SUBJECT: Forwards NUTECH evaluation of low pressure turbine roll.
 Results confirm earlier belief that present sys
 limitations associated w/intermediate range monitors
 cause 600 psi turbine roll. Mods under review.

MONTICELLO NUCLEAR GENERATING PLANT
Docket No. 50-263 License No. DPR-22

Evaluation of Feedwater Nozzle Usage Factor for
600 psi and 900 psi Turbine Roll

FIGURE 2

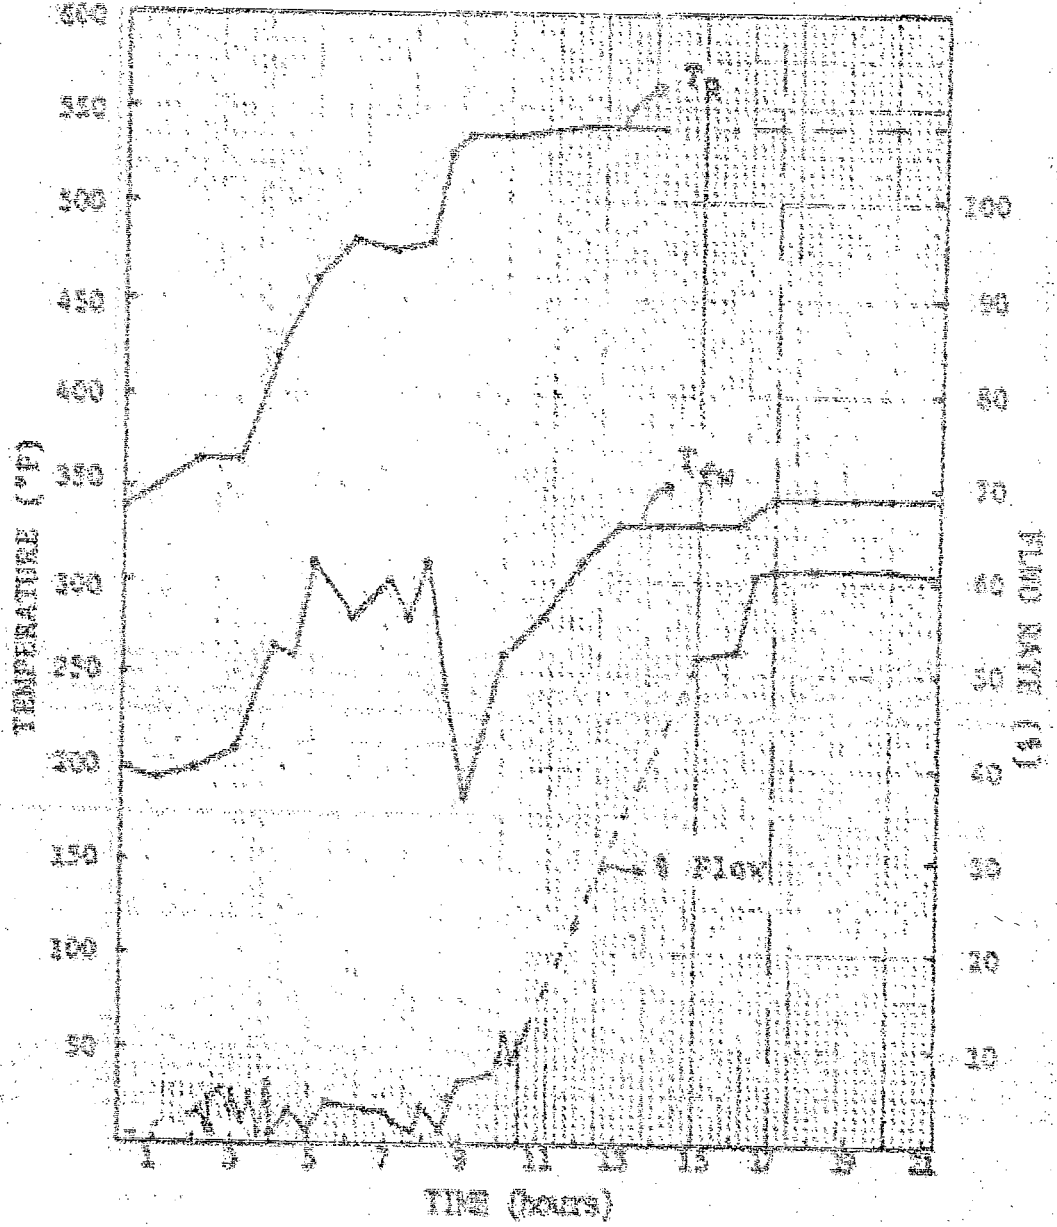
- 1) 13th line under DESCRIPTION OF STARTUPS on page two, LPRM's should be IRMs.
- 2) 1st line of second paragraph under DESCRIPTION OF STARTUPS on page two, Figure 2 should be Figure 3.
- 3) 1st line of third paragraph under DESCRIPTION OF STARTUPS on page two, Figure 3 should be Figure 2.
- 4) Table 2 should be titled, "Usage Factors in the Feedwater Nozzle for a Year of Operation."
